UNITED STATES ENVIRONMENTAL PROTECTION AGENCY
WASHINGTON, D.C. 20460

SUBJECT: Isoxaflutole Site Selection Report for Tile Drain Monitoring Studies and Prospective Groundwater Studies on Tile Drained Fields (447379-01).

FROM: Ian Kennedy, Hydrologist, and
Bill Effland, Senior Scientist,
Environmental Risk Branch II

TO: Daniel Kenny, PM Team Reviewer
Registration Division (7505C)

Figure 2.—Pattern of soils and parent material in the Clarion-Webster-Nicollet association.

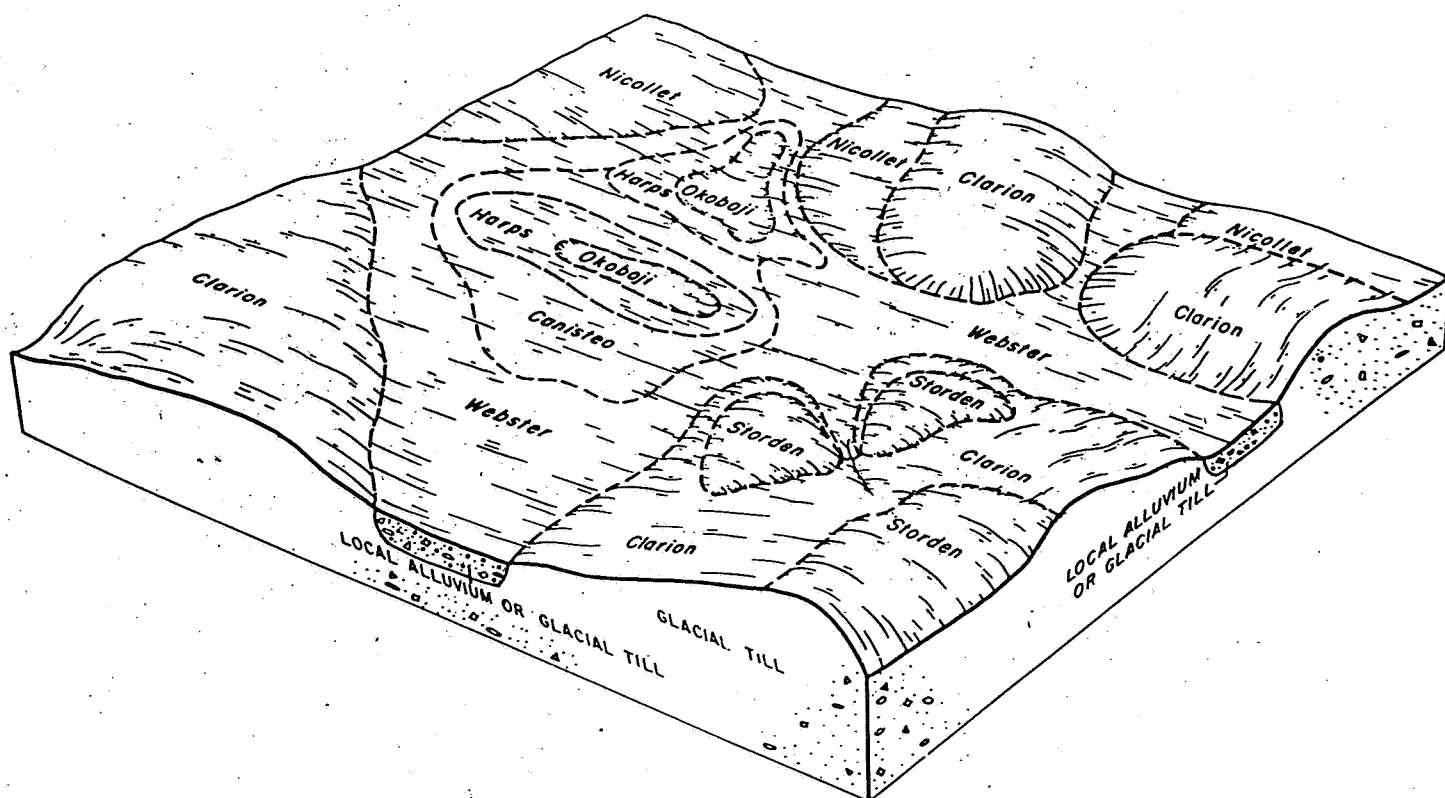
Rhône-Poulenc also did not report the drainage at the proposed sites. Drainage typical of the proposed soils is somewhat poor to very poor, but the Clarion series is well drained. Because of this, the position typical of Clarion soils at the top of rises (see attached figure) and the low water tables reported, this series makes a poor choice for a tile drain study.
